**RESPONSES TO WDEQ/LQD COMMENTS**  
**on the**  
**MINE UNIT 1 PACKAGE**

**for the**  
**LOST CREEK PROJECT**  
**Wyoming**

**March 2010**

## RESPONSES TO WDEQ\_LQD FEBRUARY 2010 COMMENTS

**Figure MU1 3-1**  
**Mine Unit 1 Soil Disturbance**  
Lost Creek Permit Area

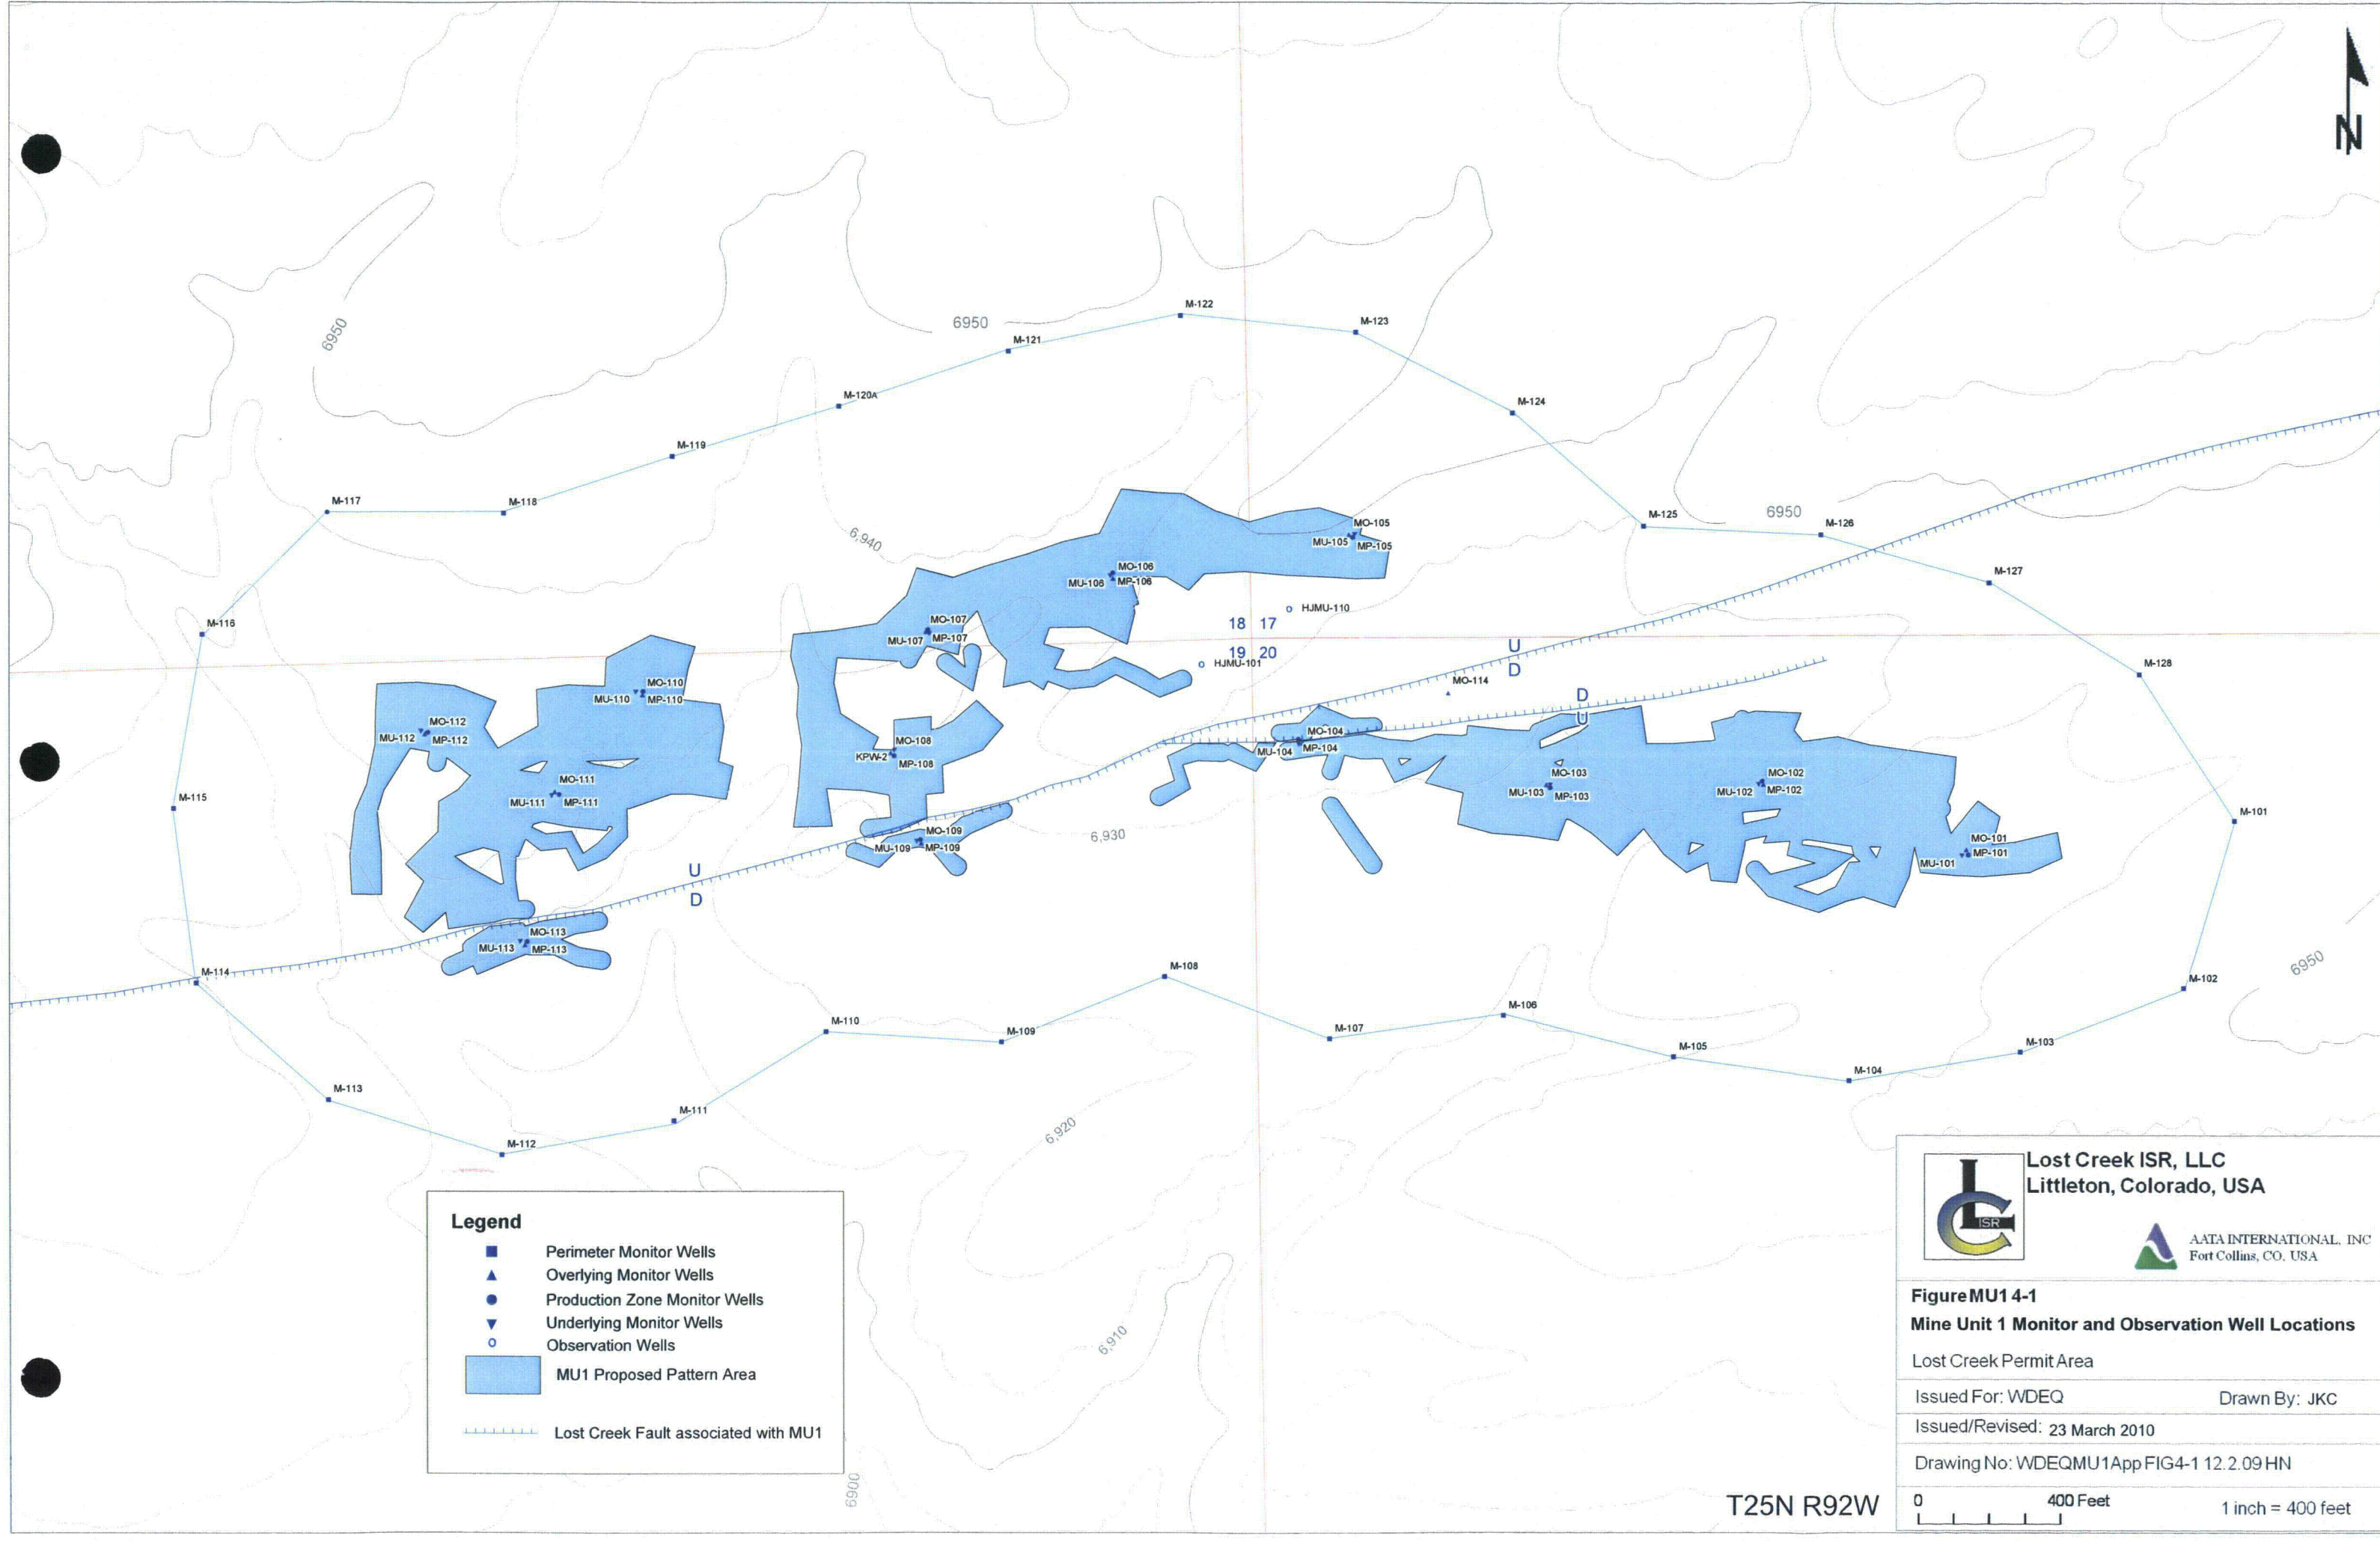
- 17) LQD (2/10) - Section 3.2 and 3.4.1 Soil Conditions and Soils. Twenty-four inches of topsoil stripping was used as a conservative estimate in order to determine the volume of topsoil to be stockpiled, yet is inaccurate. Attachment MU1 3-1 Section 4.0 indicates a topsoil depth of 19 to 24 inches for the Poposhia Loam (10% of the Study Area), six to 12 inches for the Teagulf Sandy Loam (15% of the Study Area), and 14 to 18 inches for the Pepal Sandy Loam (75% of the Study Area). Please definitively identify a recommended salvage depth for each soil series and revise Section 3.4.1, topsoil depths, topsoil stockpile volumes as appropriate. In addition, please provide a map showing topsoil suitability/stripping depths and revise table MU1 3-1 to include the depth and volume of soils to be salvaged from each of the various areas. Also, include a description of how the disturbed areas were calculated for roads and header houses.<sup>16 6</sup> (BW, MM)

LC ISR, LLC (3/10) - Table MU1 3-1 and Figure MU1 3-1 have been updated to include more site-specific information. The topsoil stockpile locations shown on Figure MU1 1-3 were not updated because those locations represent the most conservative case, i.e., the most disturbance that could be associated with topsoil stockpiles. The dimensions used for the calculations are discussed in the first paragraph in Section 3.4.

**Figure MU1 4-1**

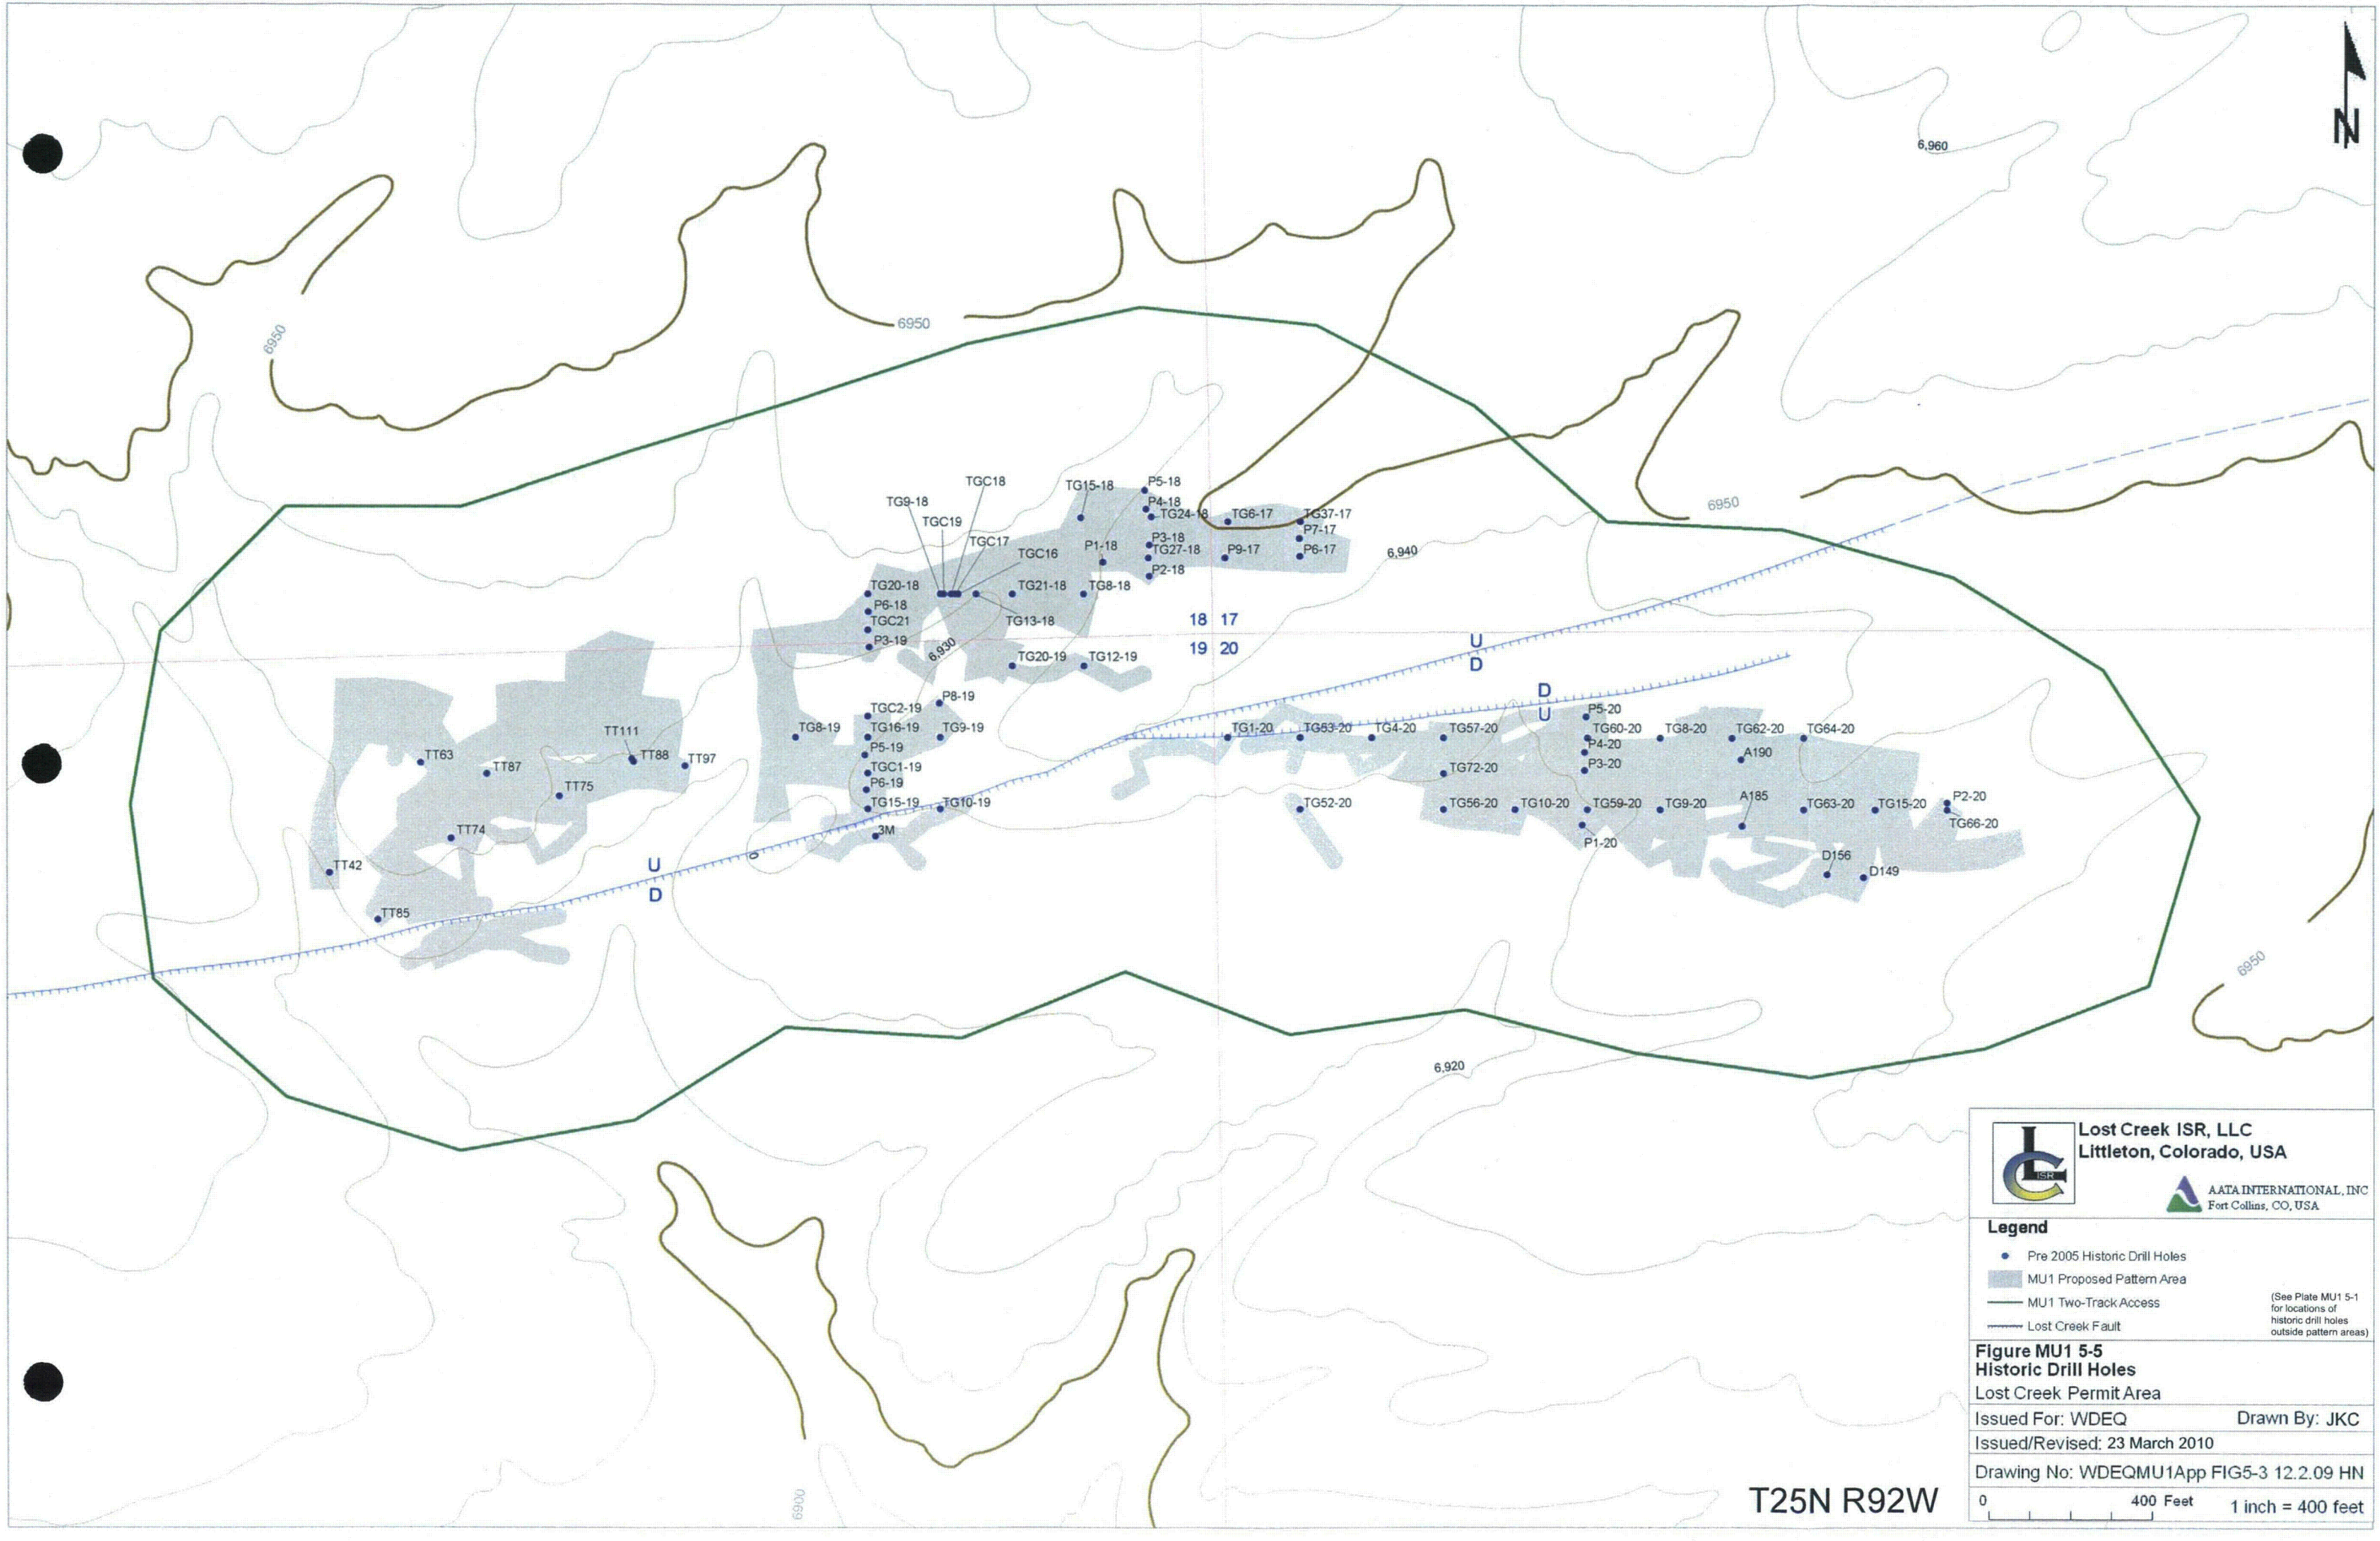
- 26) LQD (2/10) - Figure MU1 4-1 Mine Unit 1 Monitor Well Locations Attachment MU1 2-1, Appendix A, Well Completion reports. Given the MU1 Proposed Pattern Area for the various sands the spacing of the monitoring well ring needs to be justified, and each of the sands should be monitored individually. The current M wells are sometimes only screened in the Middle HJ, and would not identify an excursion in the Upper or Lower HJ. [eg the west (down gradient) end of the monitoring well ring (M-114, M-115, and M-116) are screened in the MHJ sand only, yet the pattern area to the east contains proposed production zones in the

LC ISR, LLC (3/10) - Please see Response to Comment MU1 #22.
